PRODUCT/PROCESS CHANGE NOTICE (PCN)

PCN #: **G-0206-08** DATE: 6/17/2002
 Product Affected: All square PQFP and TQFP packages shipped in Tape and Reel
 Date Effective: 9/17/2002

ATTACHMENT - PCN #: G-0206-08

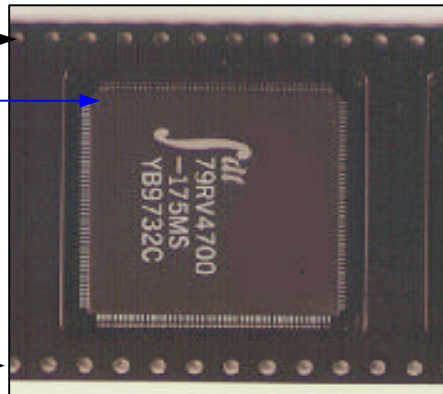
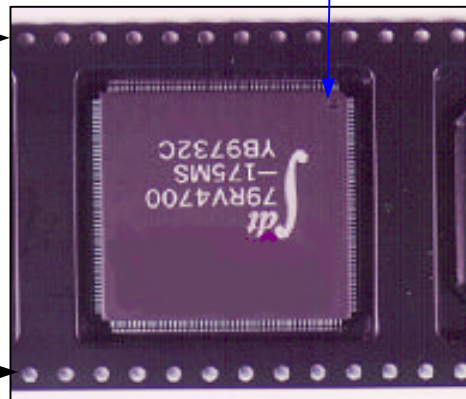
- Die Technology
- Wafer Fabrication Process
- Assembly Process Pin 1 orientation of all square PQFP and TQFP packages shipped in Tape and Reel packaging will be changed to comply with current EIA Standards (EIA-481-2-A) requirement.
- Equipment
- Material
- Testing
- Manufacturing Site Additional label will be placed on the intermediate box (pizza box) to alert customer of this change. Please see attachment for details.
- Data Sheet
- Other - Packaging

Detail of Change: This change will be implemented on all square PQFP and TQFP packages.

FROM:

TO:

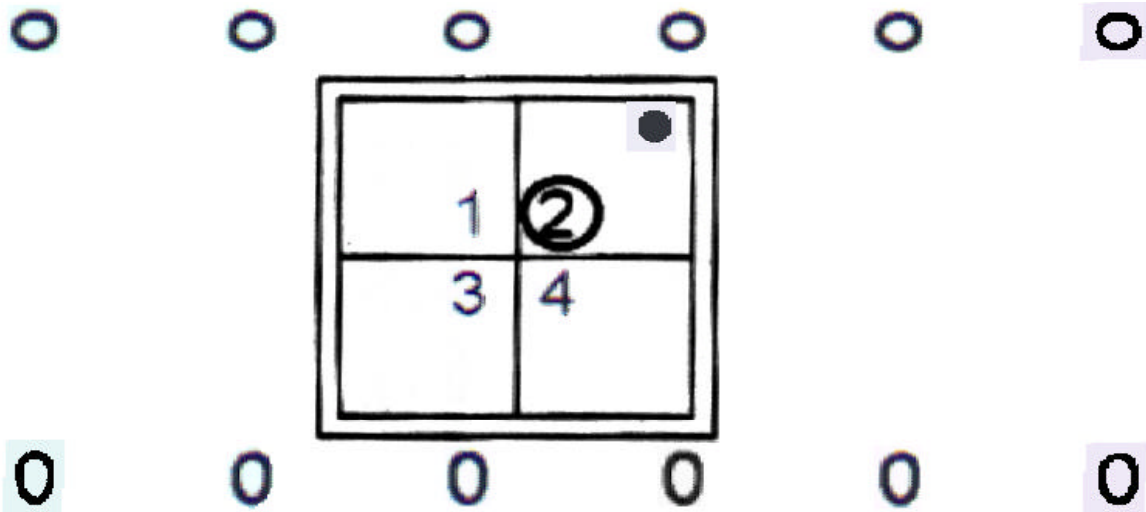
Additional label will be placed on the intermediate box (pizza box) to alert customer of this change.
Label will be placed starting (ww38) 9/17/2002 until 9/17/2003.

Additional label will be placed on the intermediate box (pizza box) to alert customer of this change.

● Pin One in Quadrant 2
